REQUEST FOR INFORMATION (RFI)

VA250-16-B-0621

PROJECT NUMBER:	506-15-101	Please ensure that before submitting questions or requests for clarification that you thoroughly read the solicitation, specifications, drawings and other pertinent documents. When submitting questions on this project the Government requires contractors to specifically identify the specification and/or solicitation section(s) or drawing number(s) in reference to the question or request for clarification submitted. No question or request for clarification will be answered by the Government unless the above requirements are met. Failure to comply may prevent the Government from responding in a timely manner.
PROJECT TITLE:	Renovate Endoscopy	
PROJECT LOCATION:	Department of Veterans Affairs Ann Arbor VAMC 2215 Fuller Rd. Ann Arbor, MI 48105

RFI NO.: 1	DATE: 11/16/16	REFERENCE:
REPLY NEEDED BY: Prior to Bid Date

WAGD EXHAUST PIPE TERMINATION DETAIL

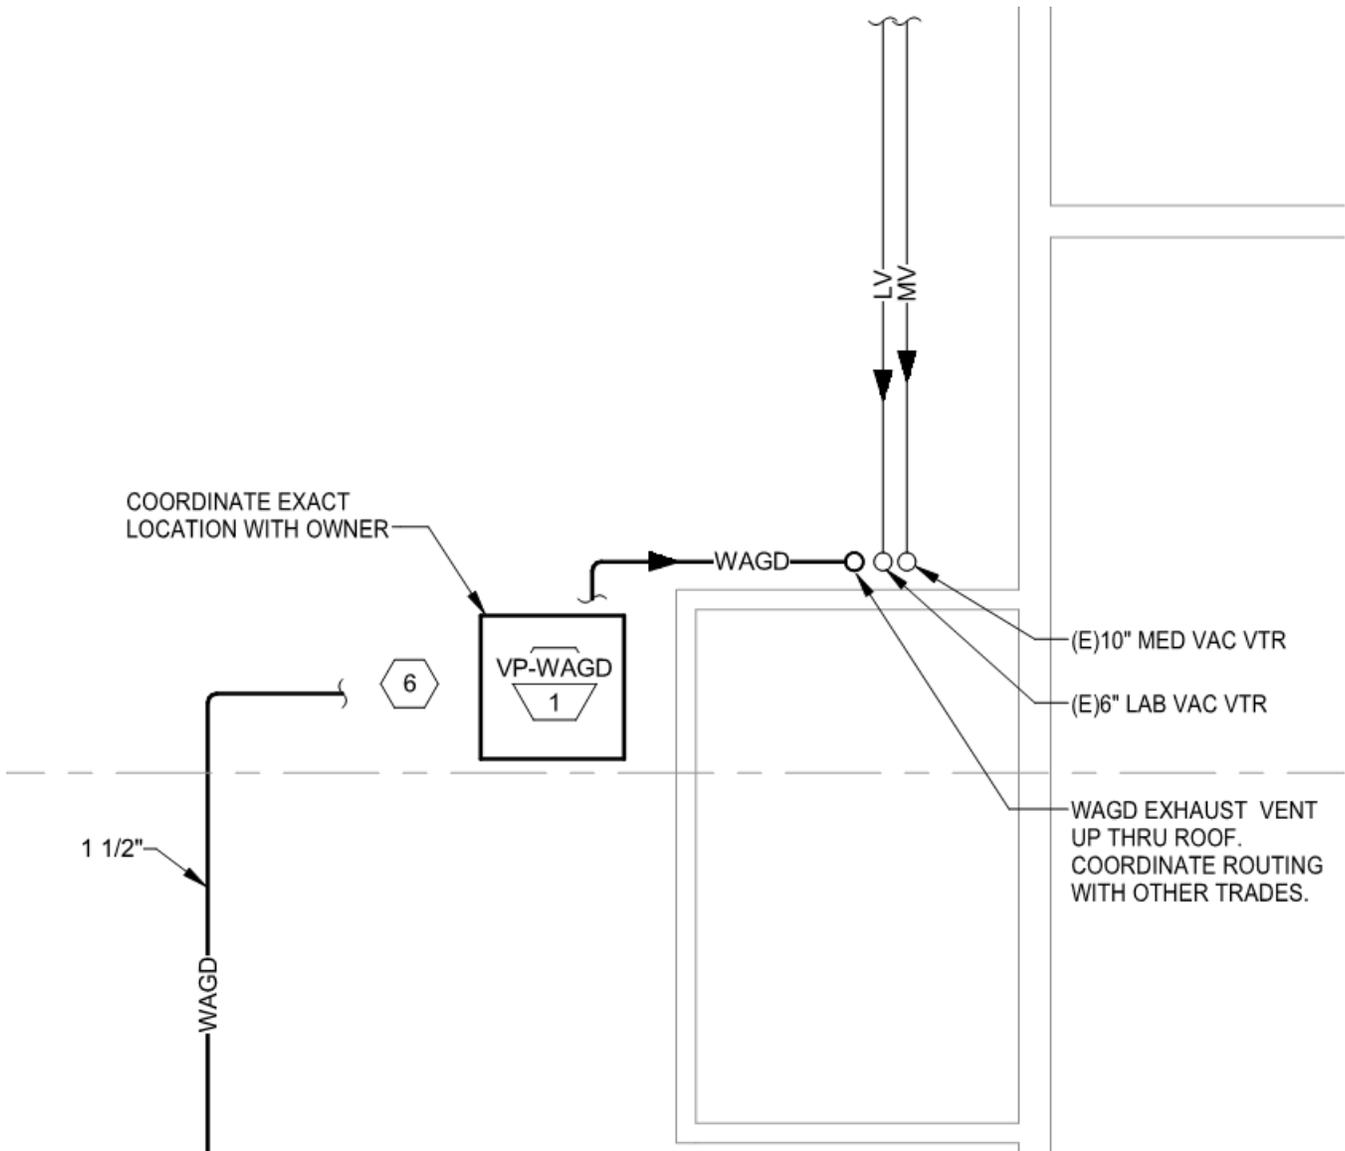
Please reference Drawing M-601 and the Vacuum Pump Detail - Drawing refers to a vent detail. We are unable to find this detail and the routing of the vent piping. Please provide detail and pipe routing.

REFER TO THE INCLUDED PDF'S:
- SK-1 FOR WAGD EXHAUST DETAIL
- SK-2 FOR WAGD VENT PIPE ROUTING
